The following remarks are responsive to the July 7, 2004 Office Action.

In re Miguel A. Frontera Castaner
Application No. 10/690,062
Response to Office Action of July 7, 2004

FIG. 7

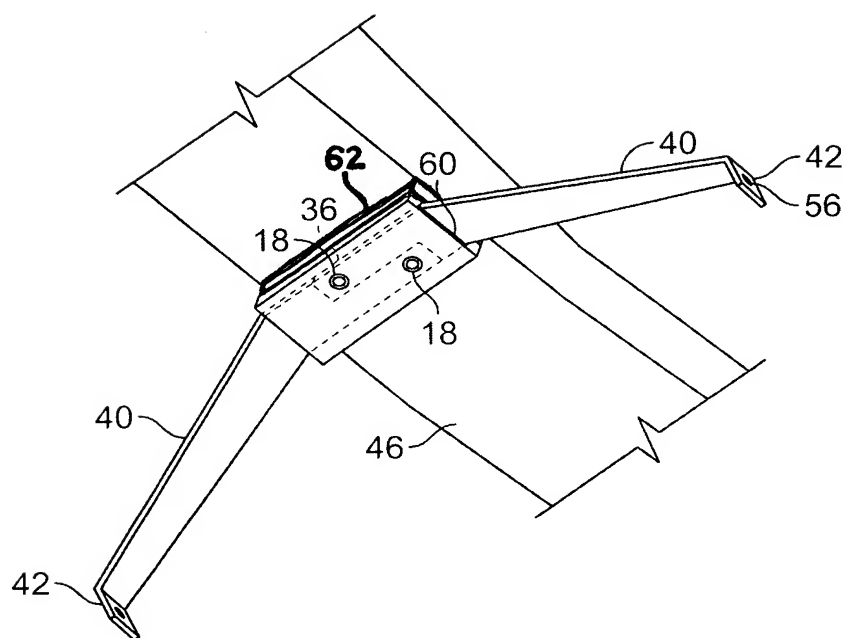
In the Office Action, the Examiner objected to the drawings because they did not include a reference to “an intermediate mounting surface 62.” New Figure 7 attached hereto shows the intermediate mounting surface 62 as described in paragraph 0029. Paragraph 0029 has been amended, and new paragraph 0022.1 added so as to reference Figure 7. No new matter is added.

The attached sheet of drawings includes new Figure 7. This sheet is the same as Figure 6 except for the addition of the previously intermediate-mounting surface 62 that was disclosed in paragraph 0029. No new matter has been added.
